# CITY OF ALBUQUERQUE

**RE: 1739 Soplo Rd SE  
Grading & Drainage Plan  
Engineer's Stamp Date: 1/19/26  
Hydrology File: N23D002  
Case # HYDR-2026-00016**

Based upon the information provided in your submittal received 1/19/2026, the Grading & Drainage Plan **is not approved** for Grading Permit or Building Permit. The following comments need to be addressed for approval of the above referenced project.

ENGINEER'S SEAL	<b>LOT 22 BLK 49A FOUR HILLS VILLAGE</b>	DRAWN BY	DEM
	<b>1739 SOPLO ROAD SE</b>	DATE	1-17-26
	<b>GRADING AND DRAINAGE PLAN</b>	1738 Soplo Road SE.dwg	
		SHEET #	C1
1/19/26	DAVID SOULE P.E. #14522	JOB #

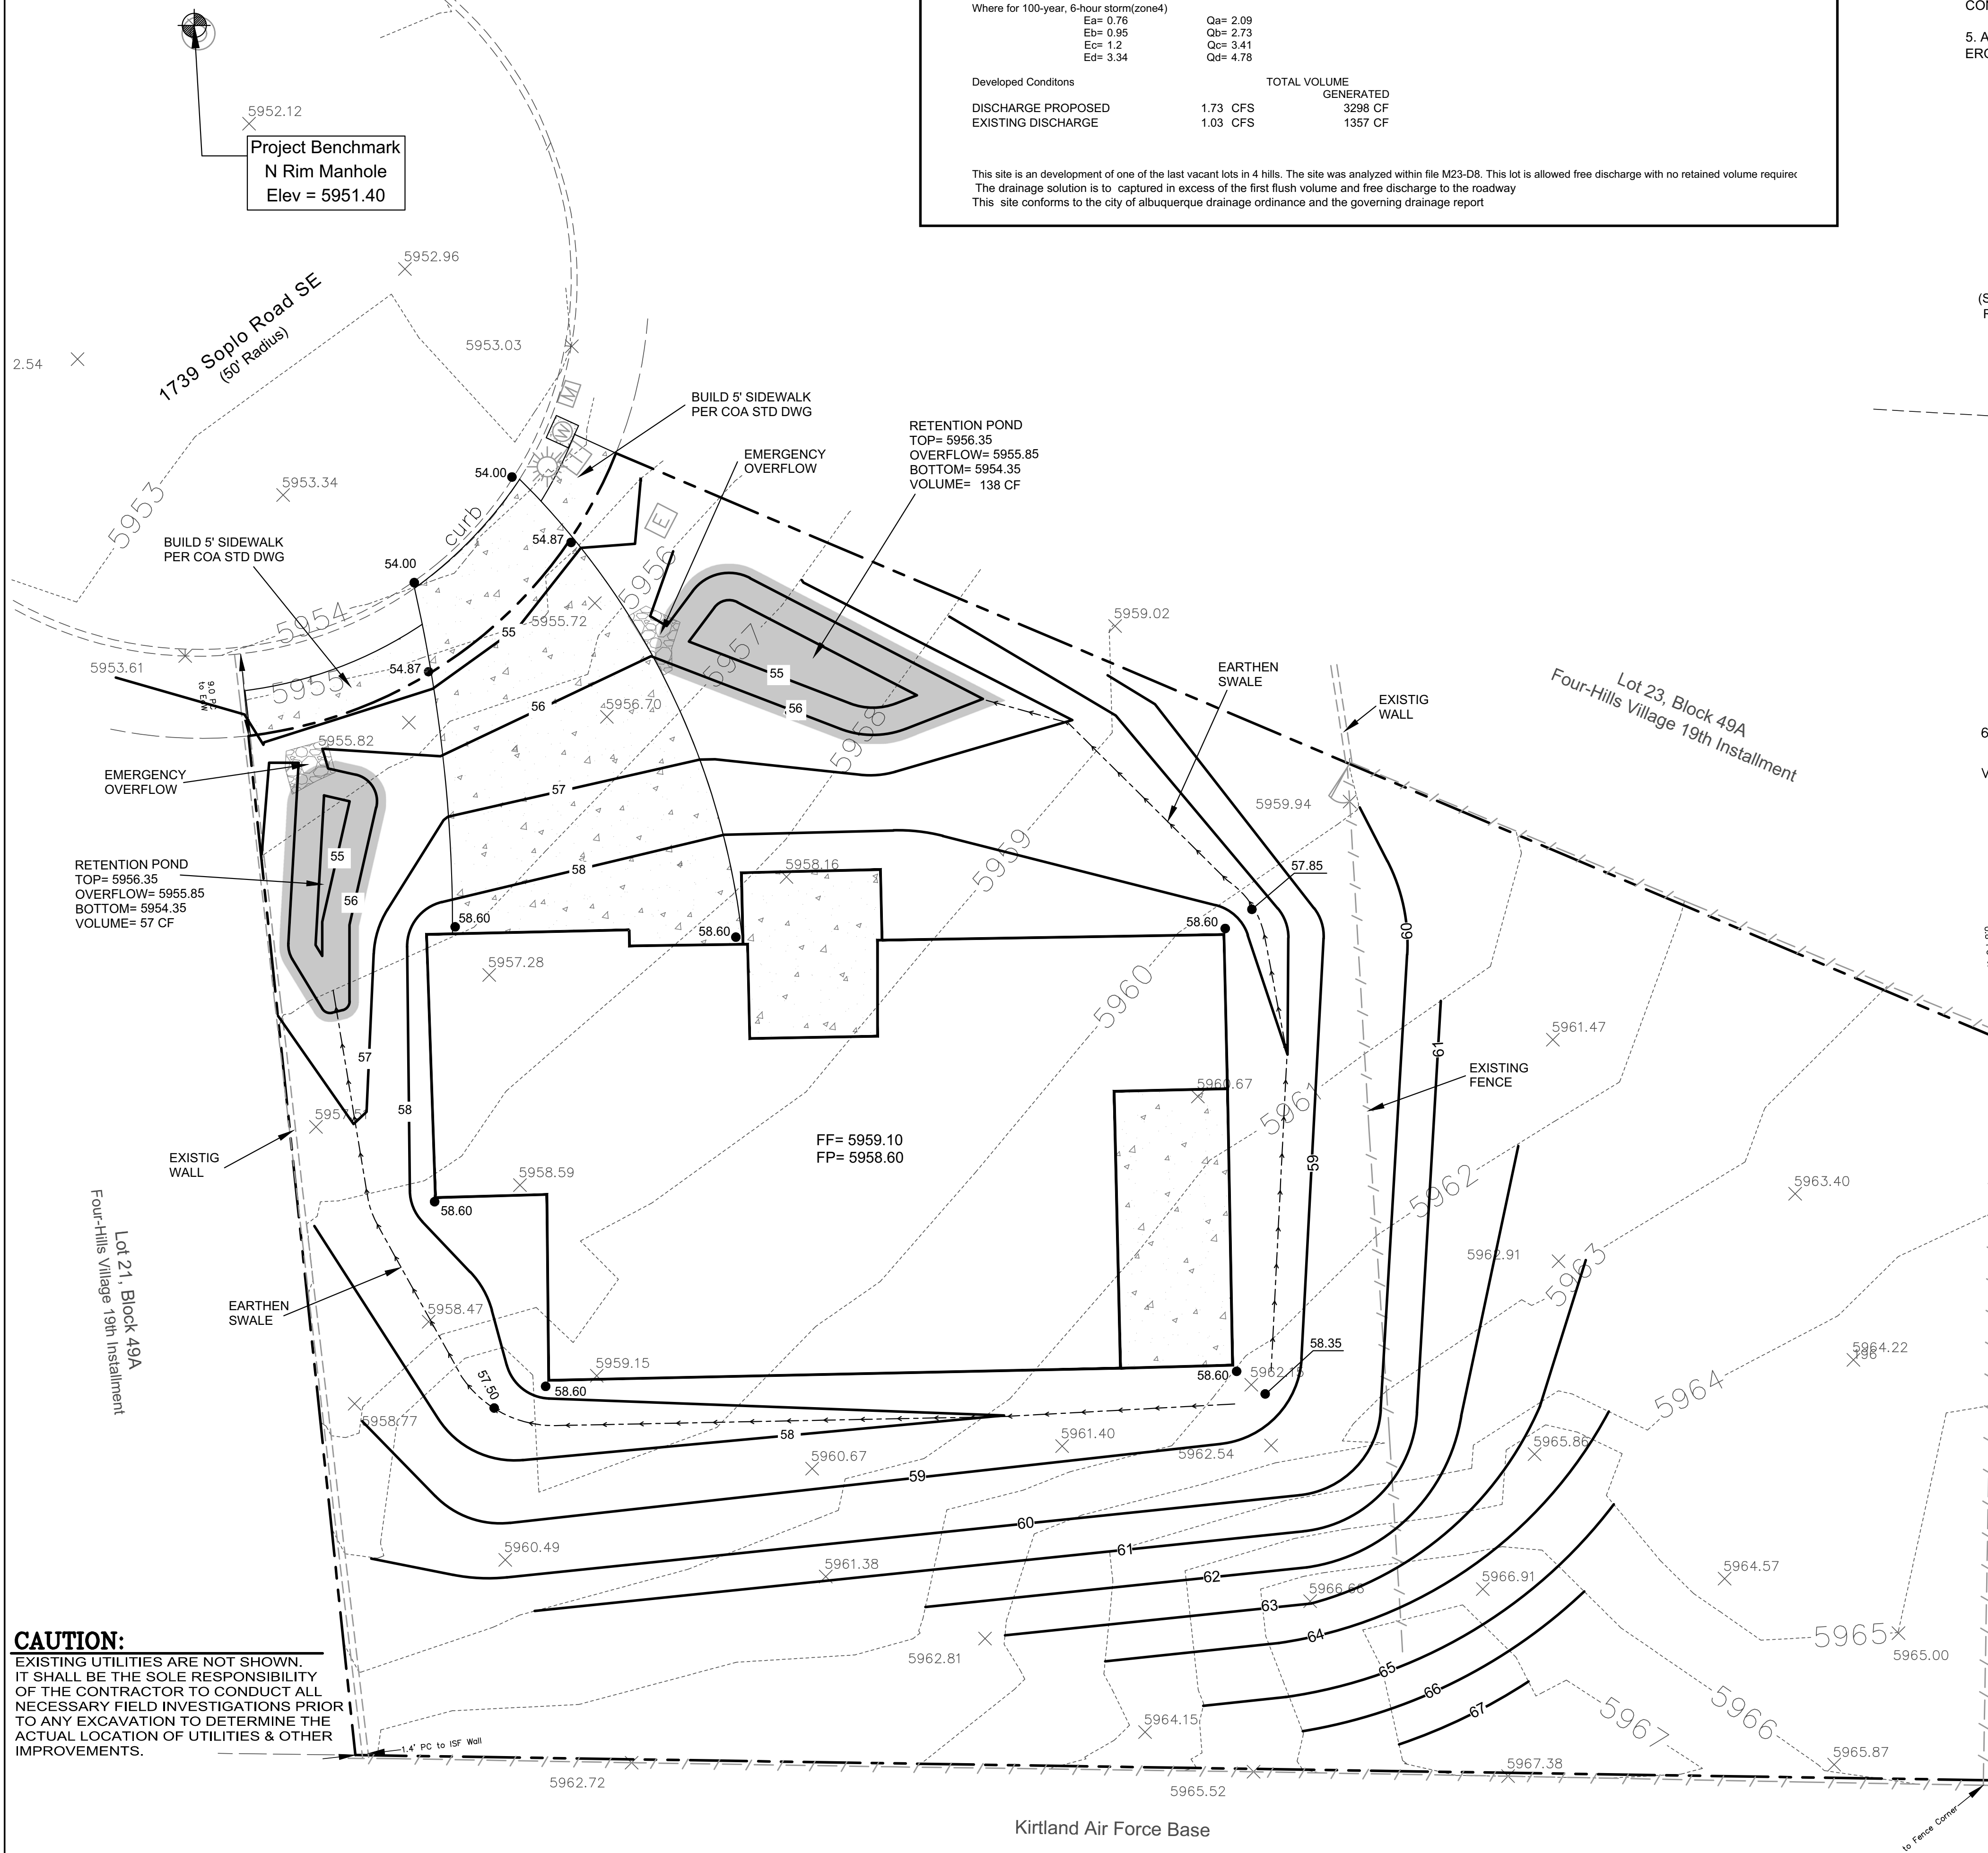
1. An SO-19 Permit will be required and should be included on the request. Please include the [standard SO-19](#) notes on the grading plan.
2. Please follow the DPM Article 6-12 Stormwater Quality and Low-Impact Development for the sizing calculations. To calculate the required SWQV, multiply the impervious area draining to the BMP by 0.42 inches for new development sites and 0.26 inches for redevelopment sites. Since this project is a new development, please use 0.42 inches for the calculation.
